1987 - 1991 Corvette: Service Bulletin: 4L60 Low & Reverse Clutch New Plate Available

Subject: 4L60 LOW & REVERSE CLUTCH NEW WAVE PLATE IS AVAILABLE

Bulletin Number: 91-186-7A - (01/29/1991)

DATE OF PRODUCTION CHANGE: (Figure 1)

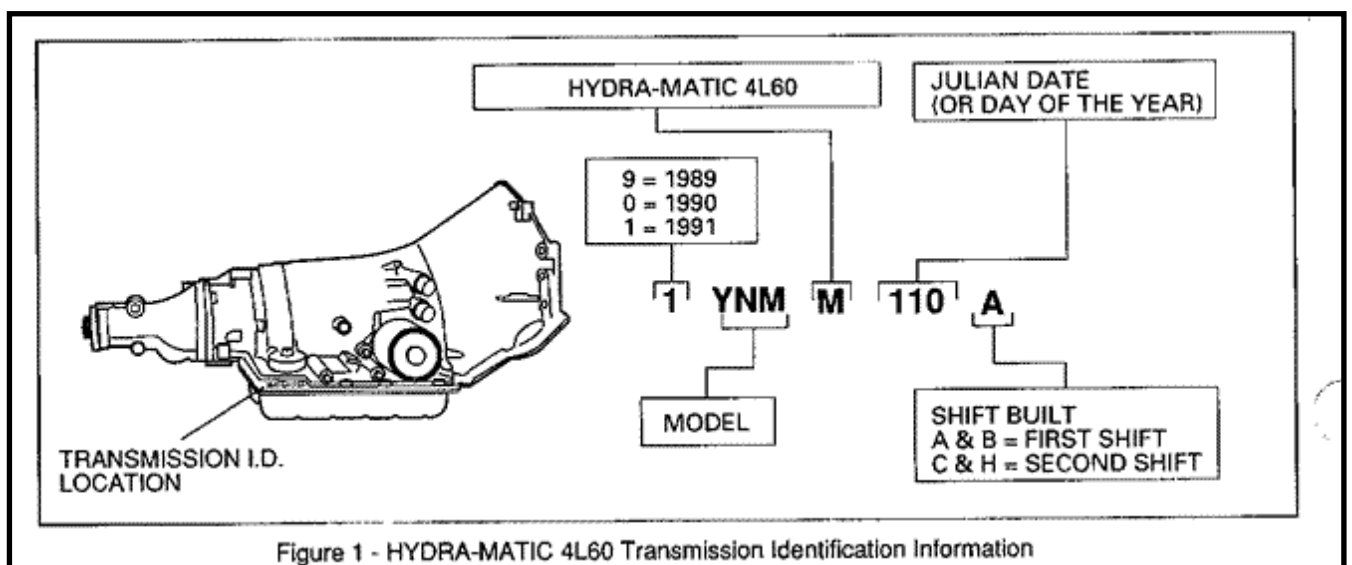
----- Beginning March 28,1990 (Julian Date 087), all HYDRA-MATIC 4L60 transmissions were built using the new low and reverse clutch wave plate.

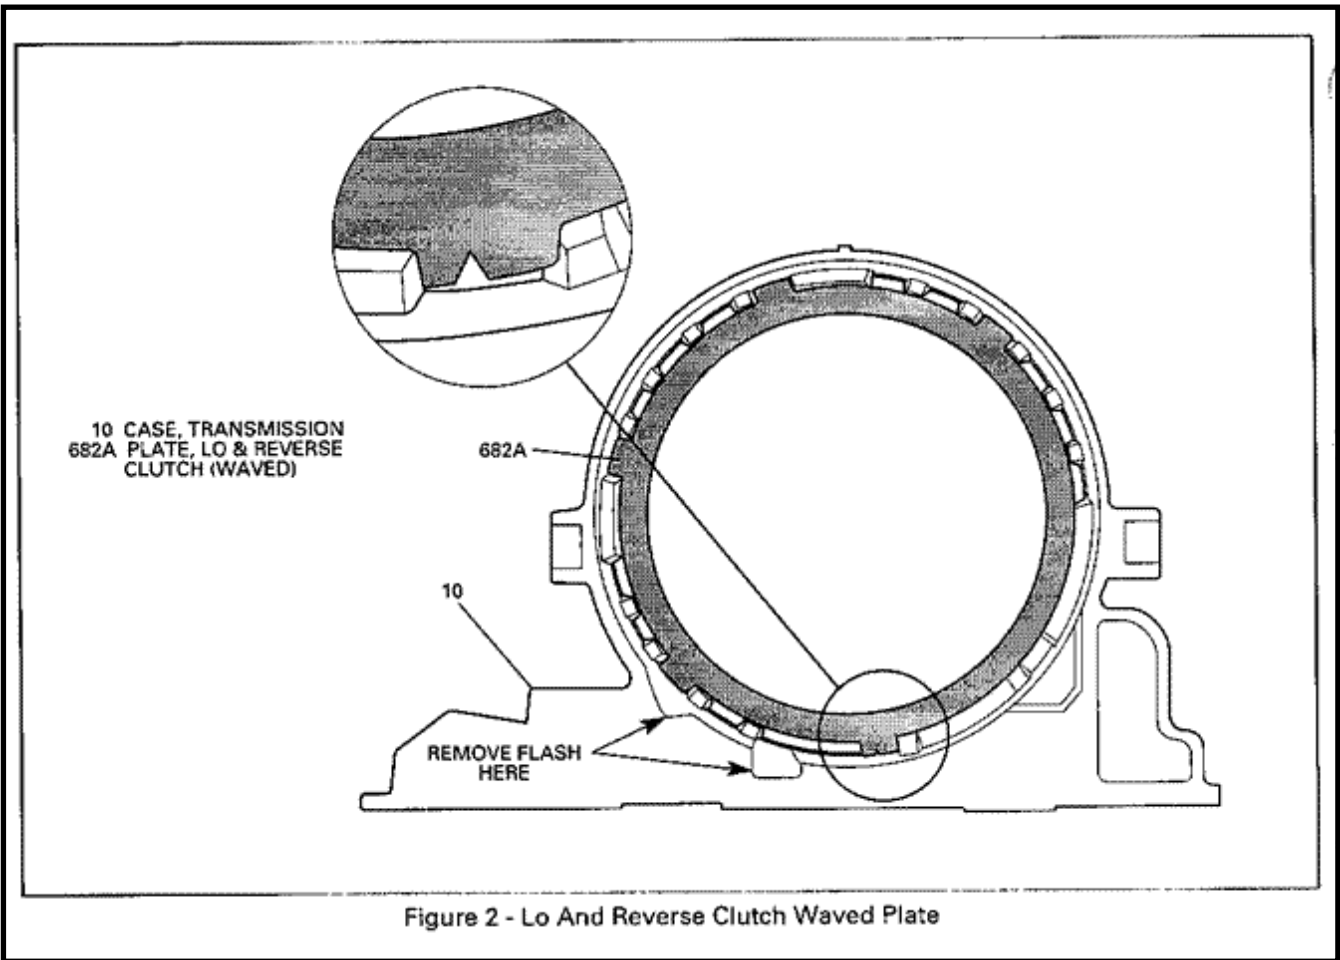
SERVICE INFORMATION: (Figure 2) ----- Low and Reverse Clutch failure can be caused by case casting flash interfering with clutch plate travel. A new wave plate is now available which will alleviate this condition. This new plate can be used to service any Hydra-matic 4L60 transmission produced after February 9, 1987 (Julian Date 040).

When installing the new wave plate, check for any case flash that may be present in the low and reverse grooves, and use a metal file to remove. See Figure 2 for case location information.
